Paul Jeffrey  
Exeter City Council Planning

## 19/1647/FUL | Land Off Ikea Way Exeter EX2 7RX: Construction of 200 dwellings

6th December 2019

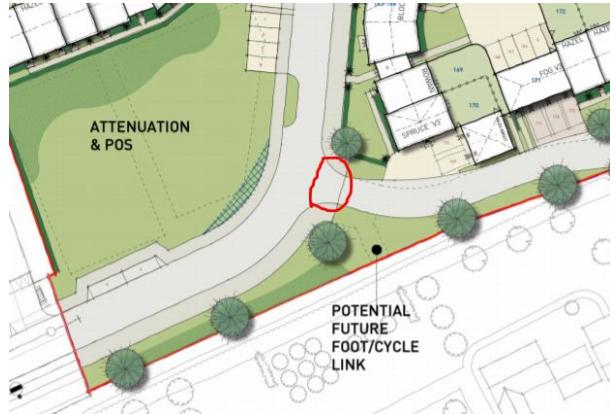
The Transport Assessment para 4.4 states: “...the slip road was no longer required due the introduction of the A379 / Russell Way traffic signal-controlled junction that permits a right turn from the A379 to Russell Way. The existing bridge section of the off slip over the A379 is retained and will be utilised as vehicular egress from the residential development. The two-way movement of pedestrian and cyclists at the bridge will also be retained”

This is currently an important, traffic-free path for people on foot or bike. This development will bring traffic over this bridge. There is currently a continuous white line demarcation of the cycle path. This will be inadequate when people cycling are mixing with buses and vehicles. The cycle/footpath needs to be physically separated from motorised vehicles (as it is further south on this route)
